CITY OF VANCOUVER
COMMUNITY SERVICES GROUP

DEVELOPMENT PERMIT STAFF COMMITTEE REPORT
MARCH 12, 2014

1545 WEST 8TH AVENUE (COMPLETE APPLICATION)
DE417504 - ZONE C-3A

DEVELOPMENT PERMIT STAFF COMMITTEE RECOMMENDATION: APPROVE

PLAN
GROUND FLOOR
1545 W 8TH
 VANCOUVER BC
 V6J 3A5T

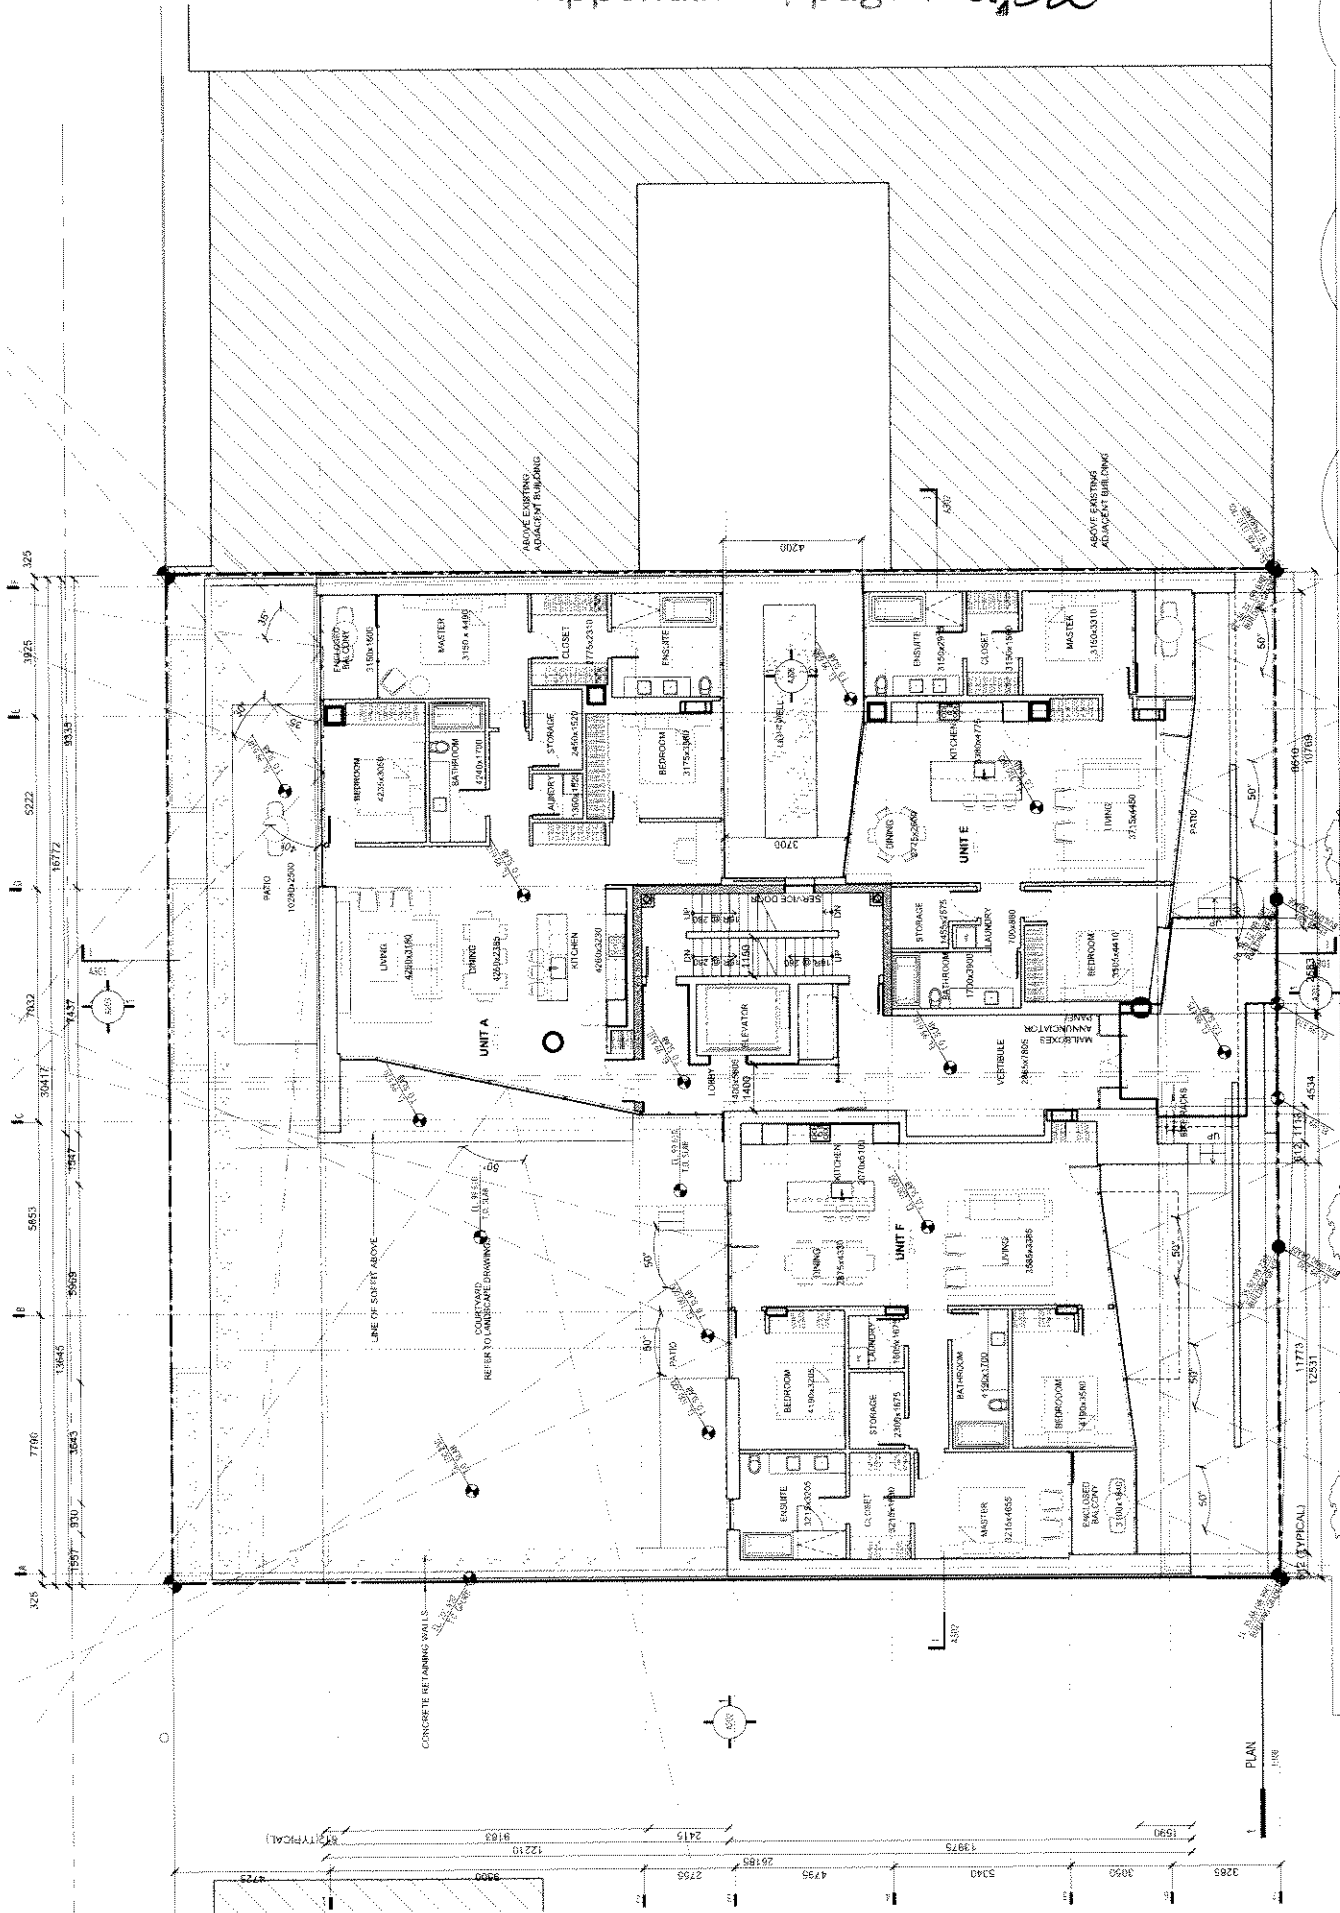
- introduce a planting screen to avert overlook at the common access courtyard entry and Unit F Patio/Dining and Bedroom beyond;

Note to Applicant: Consider reorienting Unit F patio stair access to the courtyard to achieve a planting strip at the common courtyard entrance.

- introduce a planting screen to avert overlook at the building lobby entry and bedroom Unit E;

Note to Applicant: Consider a planting screen against the angled building face from entry to top of stair Gridline D to enhance bedroom privacy;

ELEVATION
 SOUTH

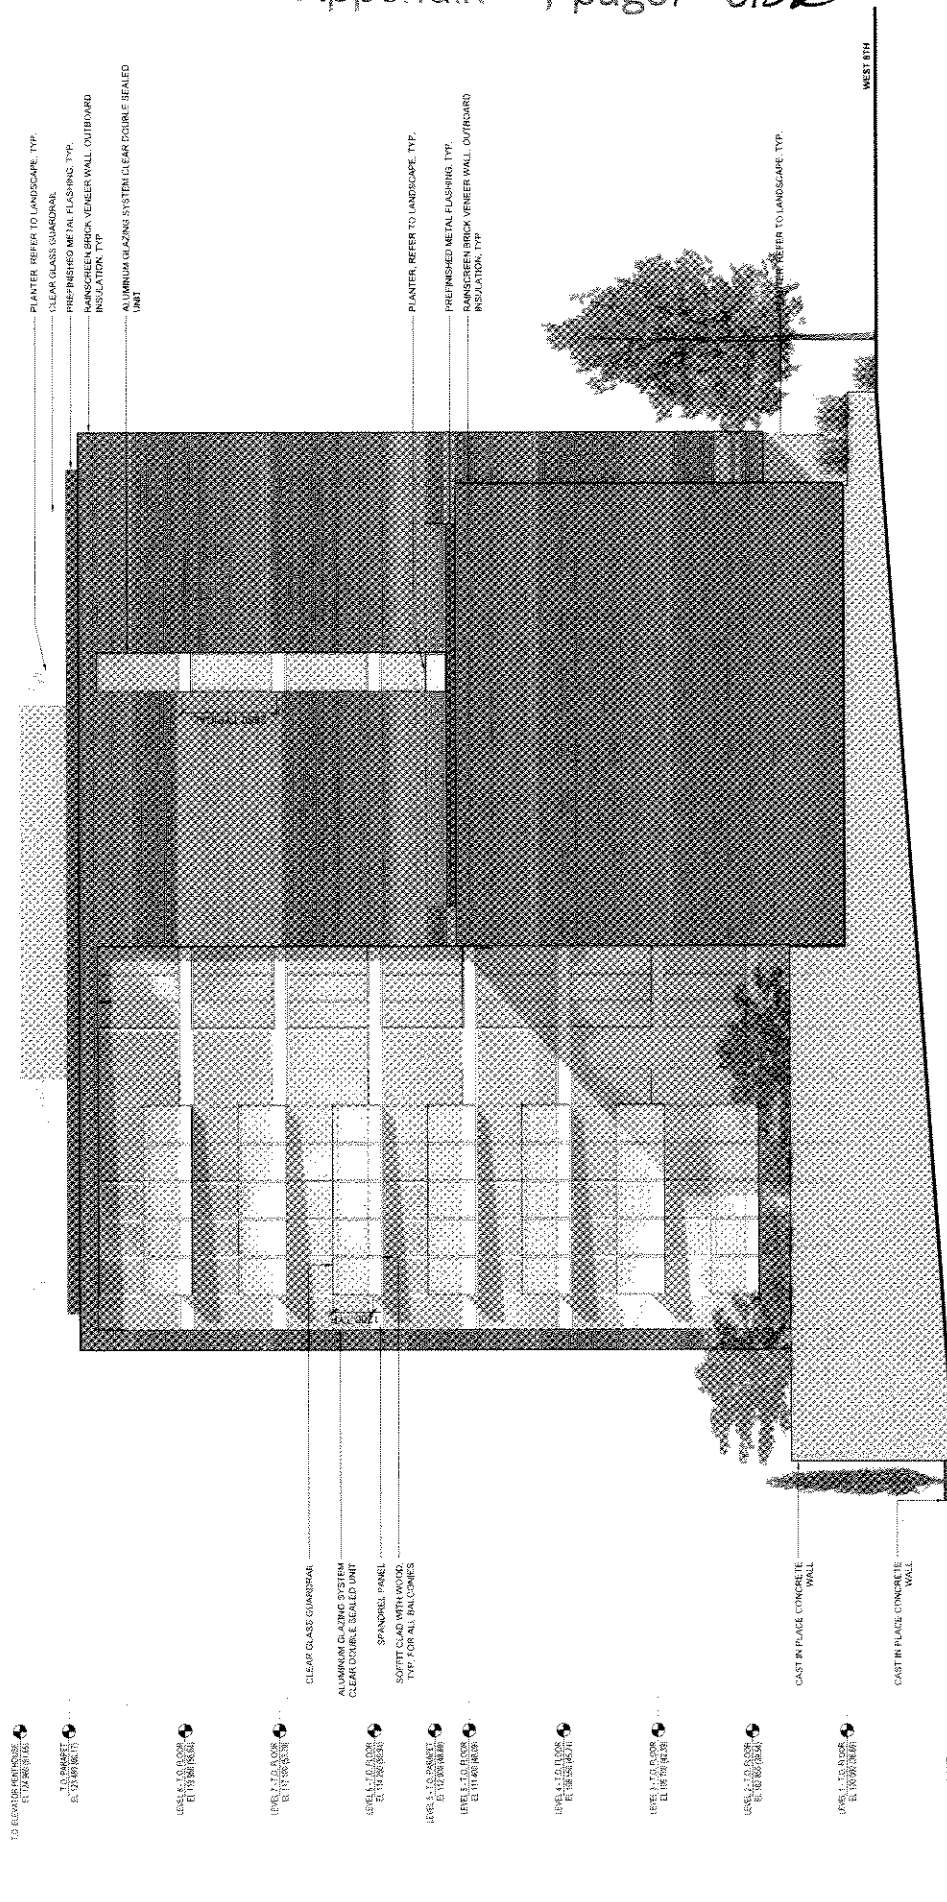
1.1 design development to improve the material expression of the eight storey wall, east property line and podium level walls, side and rear property line;

Note to Applicant: The exposed wall on the east property line at 23.8 m (78 ft.) in height will be highly visible from the street and points east of the site. While the selected masonry unit is of high quality and finish, consider an additional layer of texture potentially found in varied bonding patterns.

2 ELEVATION SOUTH
 1 ELEVATION NORTH

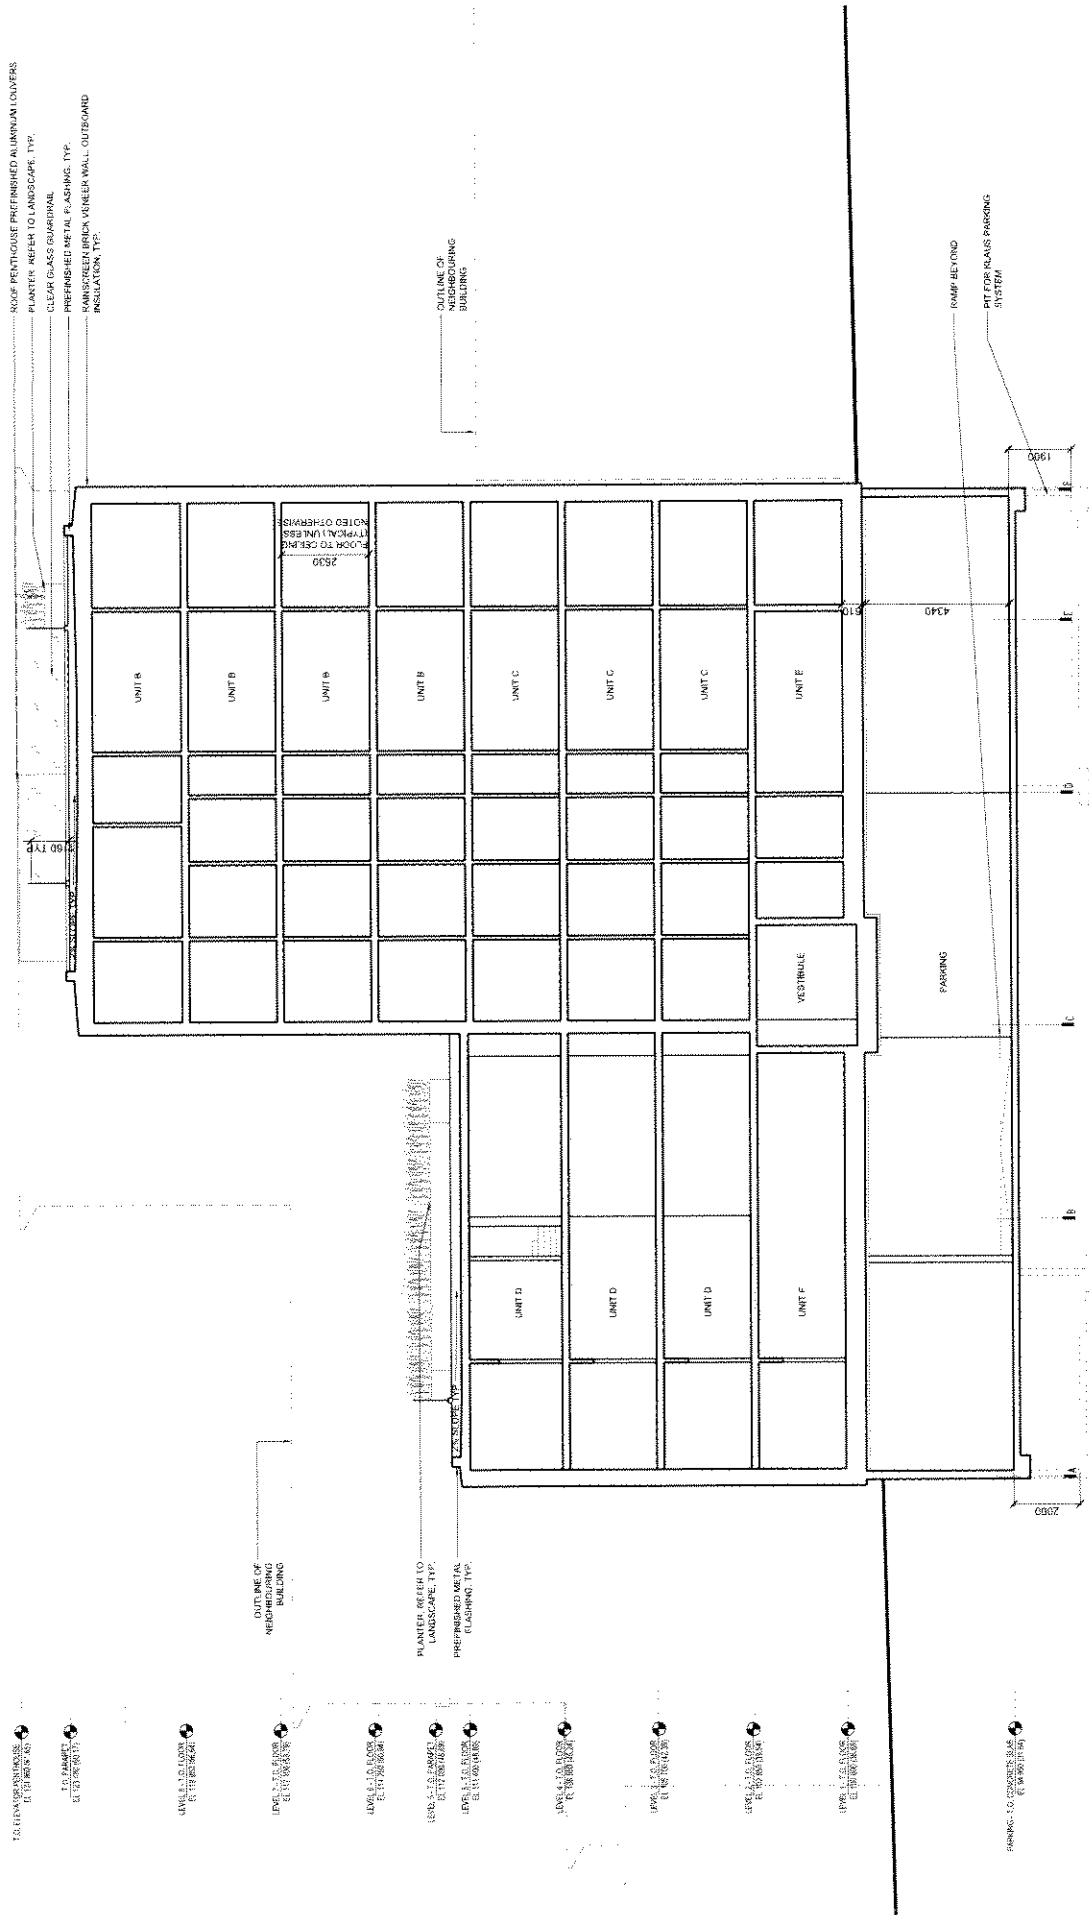
1.2 design development to improve the pedestrian scale at the lane and improve visual interest for neighboring residential development to the north;

Note to Applicant: Though the planting strip/swedish poplars along the north property line, moderate the scale of the parking structure. Consider reducing the perceived wall height with the introduction of a tempered glass guard. Transparent and consistent with other guard treatments, this effort may contribute to the visual interest found in sharing a view of the landscaped courtyard behind with neighbouring residential to the north.

Less well resolved is the impact and scale of the concrete building base at the lane. Given the 3.4 m (11 ft.) change in grade between West 8th Avenue and the lane and with the additional guard height required, the expansive face of the concrete parking structure impacts the lane. Efforts should be made to improve visual interest and pedestrian scale as experienced from the lane and adjacent residential development to the north. These concerns are covered under Condition 1.2.
